UNITED STATES PATENT AND TRADEMARK OFFICE

10/663,069

Office Action Summary

DETAILED ACTION

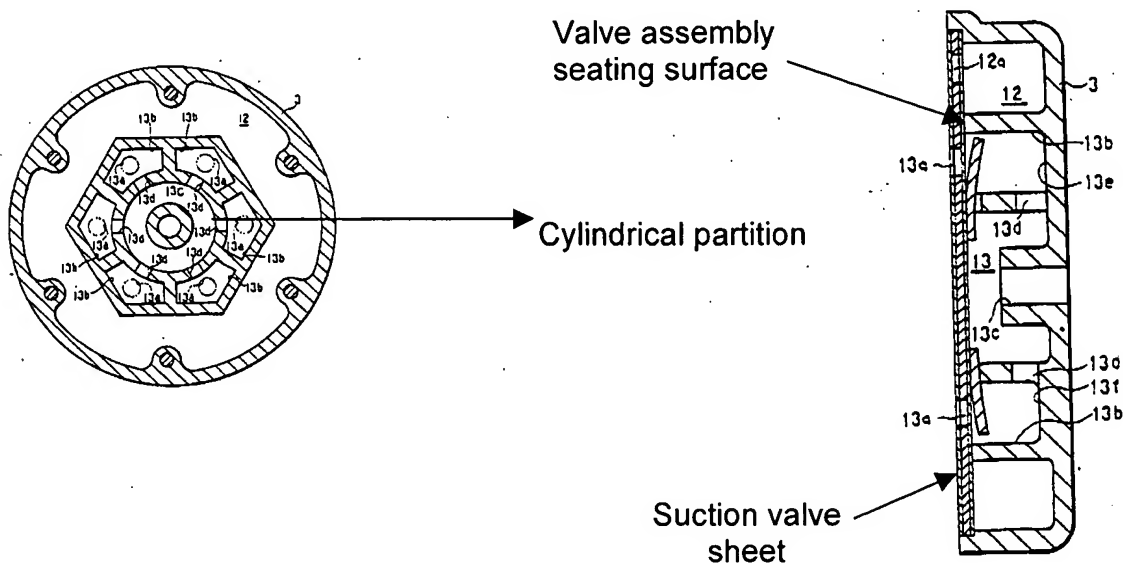
Claims 1 and 3 are rejected under 35 U.S.C. 102(b) as being anticipated by Suzuki et al (4,930,995). Suzuki et al. teach a cylinder block 1 having a cylinder 1a in which a piston 14 reciprocates; a rear housing 3 (corresponding to the claimed cylinder head) connected to the cylinder block, the rear housing defining an inlet hole 12 and being divided by a cylindrical partition (unnumbered, but clearly illustrated in Figure 2b, also see the figure below) into a first (13) and a second discharge chamber (generally described as element 13b and clearly illustrated in Figure 2c and 2b) that is serving as an outlet path; a valve assembly (unnumbered, but clearly illustrated in Figure 2c) formed between the cylinder block and the cylinder head, the valve assembly controlling refrigerant outlet flow and inlet flow to and from the cylinder. Suzuki et al. further teach a passage 13d (corresponding to the claimed at least one connecting hole) that connects the first and second discharge chambers. As illustrated in Figures 2b and 2c,

the partition is cylindrical and the space inside being defined as the first discharge chamber, and the space outside being defined as the second discharge chamber; the first discharge chamber having a valve assembly seating surface (see accompanying illustration) and the partition is provided with an inlet path therein formed without connection to the first discharge chamber. Suzuki et al. teach a valve assembly having a valve plate having an inlet port 12a (corresponding to the claimed suction port) for connecting the inlet hole and the cylinder in fluid communication; a exit port 13c (corresponding to the claimed discharge port) for connecting the cylinder and the first discharge chamber in fluid communication; a suction valve sheet (unnumbered but illustrated in the accompanying illustration) having a suction valve for opening and closing the inlet port 12a; a discharge valve sheet having a discharge valve for opening and closing the discharge port.

Applicant argues that Suzuki does not teach a cylindrical partition separating the two discharge chambers. As explained above Suzuki teaches a cylindrical partition (unnumbered, but clearly illustrated in Figure 2b, also see the figure above) into a first (13) and a second discharge chamber (generally described as element 13b and clearly illustrated in Figure 2c and 2b).
